PRODUCT CHANGE NOTIFICATION (PCN)

AMJE0909-0300-BUB-24
MODULAR CABLE

CHANGE NOTIFICATION: PCN 20220509_AMJE0909-0300-BUB-24

DESCRIPTION OF CHANGES:
CHANGE OF DATA SHEET
CHANGE OF DATA SHEET
New Draw.-No. ASS_7945_CArev02

AMJE0909-0300-BUB-24 OLD VERSION

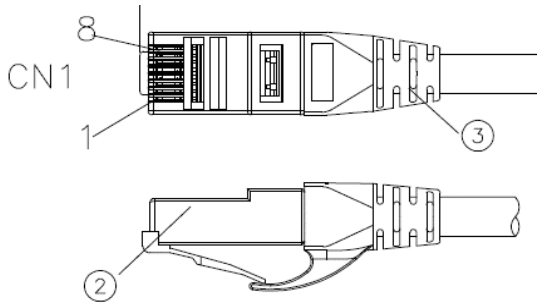
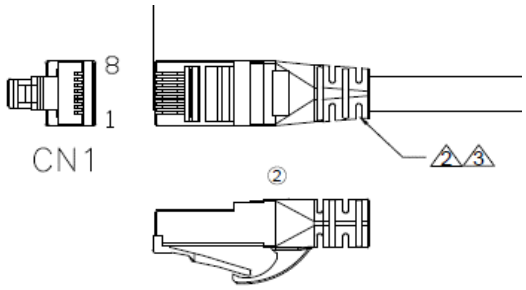
③	Molding	PVC 45P Color: see order code	NA	KG
②	CONNECTOR	RJ45 8P8C two fork Short type 3u" gold plated	2	PCS
①	CABLE	CAT6 UTP (24AWG*1PR)*4+PVC OD=5.8±0.3MM Color: see order code	NA	MM
NO:	NAME	DESCRIPTION	Q'TY	UNIT

3	Molding	PVC 65P Color: see order code ②	NA	KG
2	CONNECTOR	RJ45 8P8C PLUG 3u" gold plated ②	2	PCS
1	CABLE	CAT6 U/UTP (24AWG*1PR)*4+Cross+PVC Jacket OD=5.8± 0.3MM Color: see order code ②	NA	MM
NO:	NAME	DESCRIPTION	Q'TY	UNIT

Drawing-No.
ASS 7945 CA

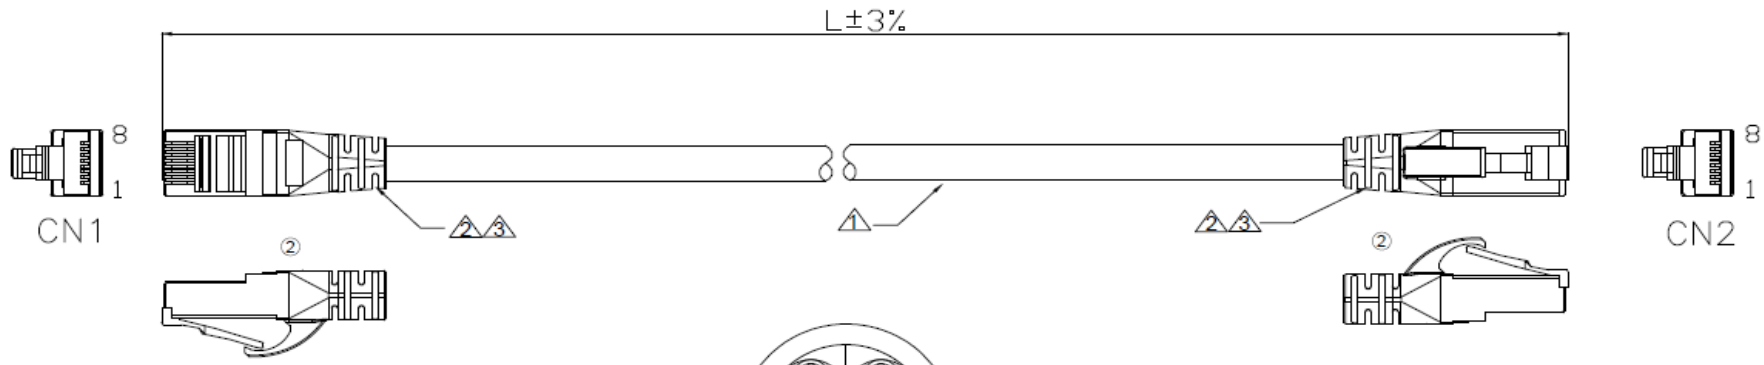
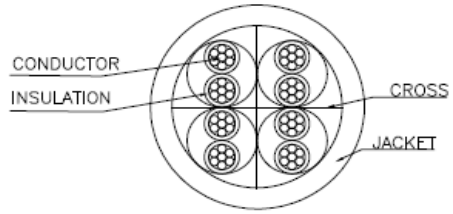
Id.	Modification	Date	Name
②	Change the plant	09.05.2022	Luca
①	Update the WSW order code	02.06.2017	Amy
⓪	Drawn	30.03.2017	Amy

NO:	NAME	DESCRIPTION	Q'TY	UNIT
3	Molding	PVC 65P Color: see order code ②	NA	KG
2	CONNECTOR	RJ45 8P8C PLUG 3u" gold plated ②	2	PCS
1	CABLE	CAT6 U/UTP (24AWG*1PR)*4+Cross+PVC Jacket OD=5.8± 0.3MM Color: see order code ②	NA	MM
